2. AMENDMENT/MODIFICATION NO. 0005	3. EFFECTIVE DATE OCT 08, 2004	4. REQUISITION/PURCHASE REQ. NO. N/A	5. PROJECT NO. (If applicable) SPEC. NO. 1389
6. ISSUED BY CODE		7. ADMINISTERED BY (If other than Item 6) CODE	
DEPARTMENT OF THE ARMY U.S. ARMY ENGINEER DISTRICT, SACRAMENTO SACRAMENTO, CALIFORNIA 95814-2922		DEPARTMENT OF THE ARMY U.S. ARMY ENGINEER DISTRICT, SACRAMENTO SACRAMENTO, CALIFORNIA 95814-2922

14. DESCRIPTION OF AMENDMENT/MODIFICATION (Organized by UCF section headings, including solicitation/contract subject matter where feasible.)  
Fitness Center  
Hill AFB, Utah

1. Revised Pages: SF 1442 (2 pages), 00100-2, 00100-4, 00100-5, Attachment No. 20 (SK-6 & SK-6A), 01011-11-4, Section 01011 (Chapters; D53, D62, D7), 01505-9,

1. Schematic Diagram - Communications Fiber Optic Site Plan  
 (see also floor plan)

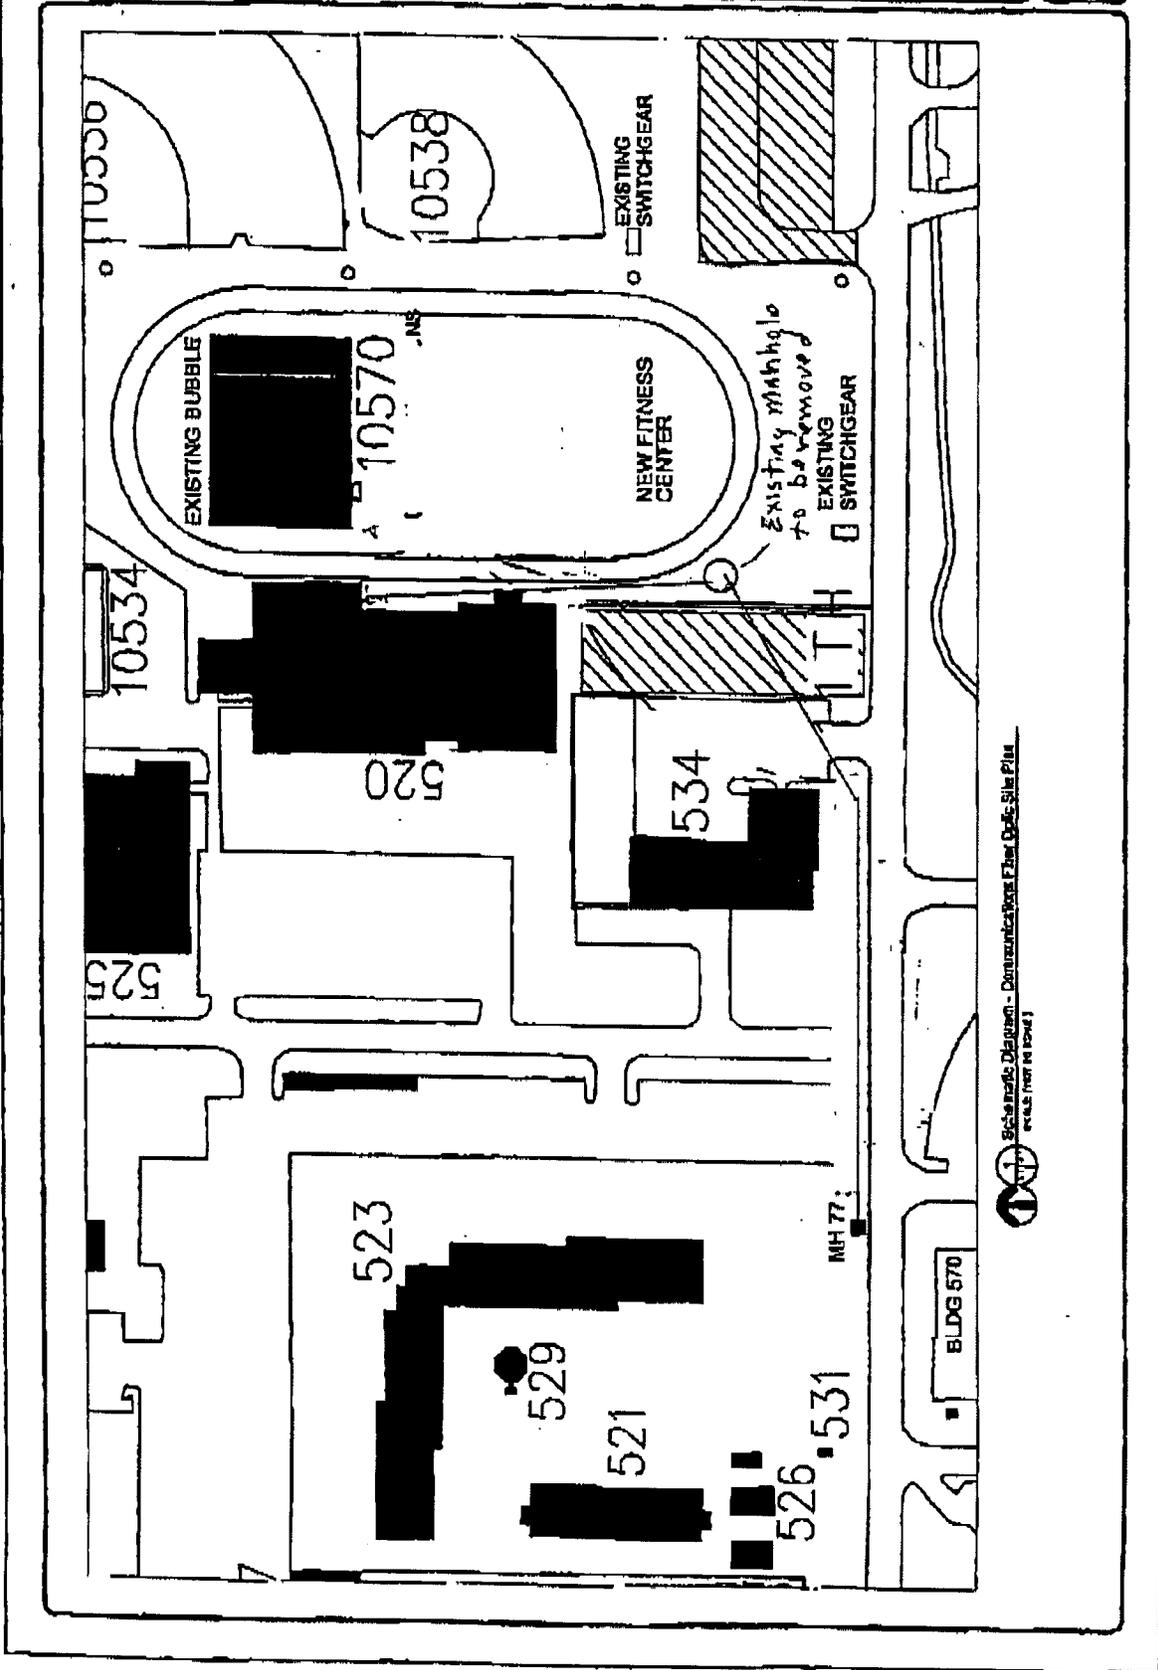
- 1.1.4 Manholes:
- Provide two new manholes at sites indicated on drawing (attachment 20). Manhole dimensions are 10' L x 8' W x 7' D.
- 1.1.5 Copper Cable:
